# UNITED STATES PATENT AND TRADEMARK OFFICE

10/801,119

<b>Office Action Summary</b>	<b>Application No.</b> 10/801,119	<b>Applicant(s)</b> NEUMANN, CARSTEN	
	<b>Examiner</b> Nicholas Woodall	<b>Art Unit</b> 3733

### **DETAILED ACTION**

Figure 1

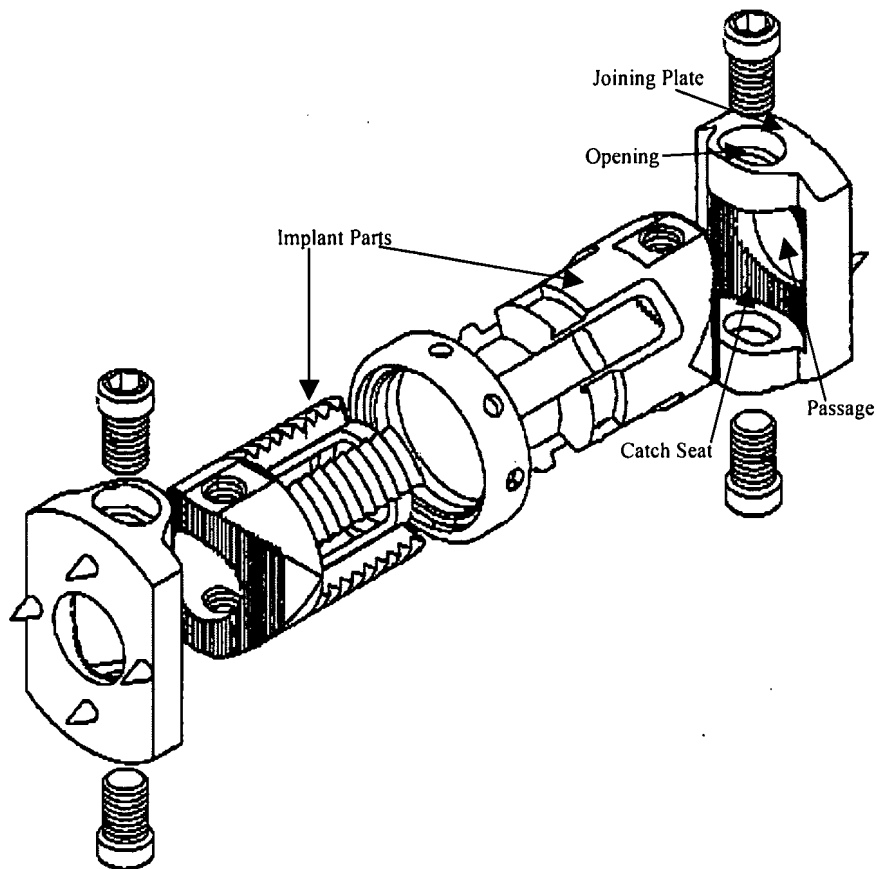
5. Claims 1, 3, 5, 9, 10, 17, 23, and 24 are rejected under 35 U.S.C. 102(b) as being anticipated by Yeh (U.S. Publication 2003/0045877).

Regarding claim 1, Yeh discloses a device comprising at least two implant parts. The two implant parts comprising a first implant part, a second implant part, and a joining plate that is capable of being releasably connected with an end of the first implant part or the second implant part (see Figure 1 below). The joining plate further includes an opening capable of being used for releasable attachment of the joining plate, wherein the opening is capable of being located outside the center of gravity of the joining plate. The first implant part and the second implant part are axially adjustable relative to each other along the longitudinal axis of the device. Regarding claim 3, Yeh discloses a device wherein the joining plate projects beyond an outside contour of the device. Regarding claim 5, Yeh discloses a device wherein the shape of the opening is capable of being contoured to an outside contour of the device. Regarding claim 9, Yeh discloses a device wherein the joining plate includes a means for attachment and is

capable of being attached to at least one of the at least two implant parts. Regarding claim 10, Yeh discloses a device further comprising a catch seat wherein the means for attachment is formed by a plug-in connection between the joining plate and at least one of the two implant parts. Regarding claim 17, Yeh discloses a device wherein the joining plate includes a passage opening. Regarding claim 23, Yeh discloses a device wherein the joining plate has a side that faces the vertebrae and is capable of being inclined relative to the longitudinal axis of the device. Regarding claim 24, Yeh discloses a device wherein the joining plate has a side that faces the at least two implant parts and is capable of being inclined relative to the longitudinal axis of the device.

Figure 2

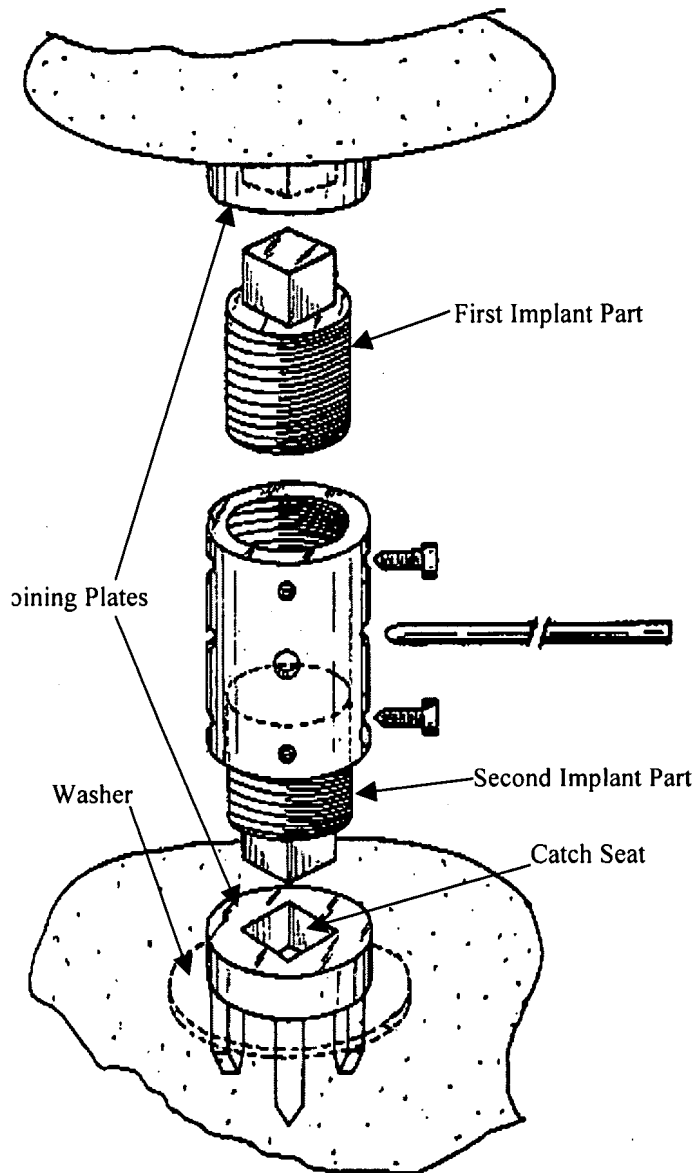
6. Claims 1-6, 9, 10, and 15 are rejected under 35 U.S.C. 102(b) as being anticipated by Daher (U.S. Patent 4,657,550).

Regarding claim 1, Daher discloses a device comprising at least two implant parts and a joining plate. The at least two implant parts are axially adjustable relative to each other. The joining plate is capable of being releasably connected with a free end with at least one of the two implant parts and is substantially perpendicular relative to the longitudinal axis of the implant (see Figure 2 below). The joining plate further includes an opening capable of being used for releasable attachment of the joining plate, wherein the opening is capable of being located outside the center of gravity of the joining plate. Regarding claim 2, Daher discloses a device wherein the joining plate has a thickness that is between 2% and 30% the height of at least one of the two implant parts. Regarding claim 3, Daher discloses a device wherein the joining plate includes a washer that projects beyond the outside contour of the implant parts. Regarding claim 4, Daher discloses a device further comprising a means for releasable attachment of the joining plate wherein the means is an opening formed in the joining plate. Regarding claim 5, Daher discloses a device wherein the shape of the opening in the joining plate is adapted to the outside contour of the implant parts. Regarding claim 6, Daher discloses a device wherein the opening in the joining plate is positioned in the center of gravity of the joining plate. Regarding claim 9, Daher discloses a device wherein there are two joining plates which have a means for attachment that is an opening in the joining plates that are attached to at least one of the implant parts. Regarding claim 10, Daher discloses a device further comprising a catch seat that is

part of the plug-in connection that forms the attachment means between the joining plate and at least one of the implant parts. Regarding claim 15, Daher discloses a device wherein the joining plate is circular shaped.
